CORRECTION

WIRING DIAGRAM OF AN AMPLIFIER FOR DIFFERENTIAL THERMAL ANALYSIS

CARL W. BECK, *University of New Mexico, Albuquerque, New Mexico.*

FIG. 2. Schematic diagram of amplifier.

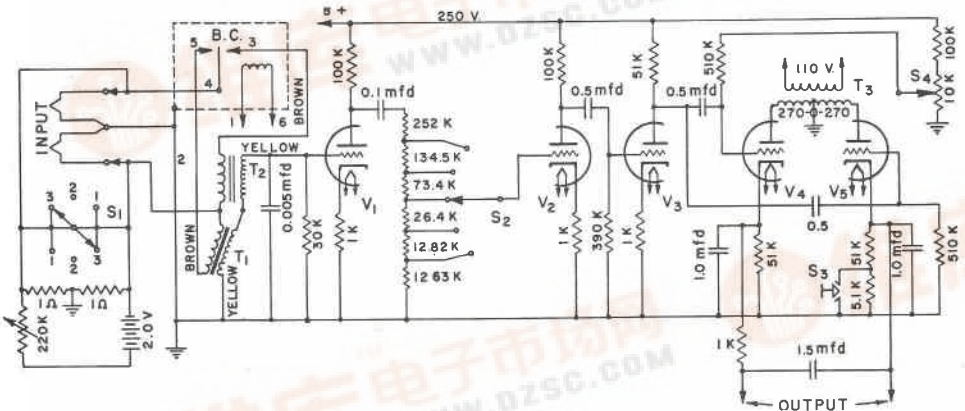
Attention has been called to two drafting errors in Figure 2, p. 509, *Am. Mineral.*, Vol. 35. (1) The wire coming from S_4 should not connect to the 250V line—if the S_4 were turned down to the ground end it would short out the power supply. (2) The grid on tube V_5 is grounded—this is corrected by adding a 510K grid leak. Both of these errors have been corrected on the wiring diagram below.
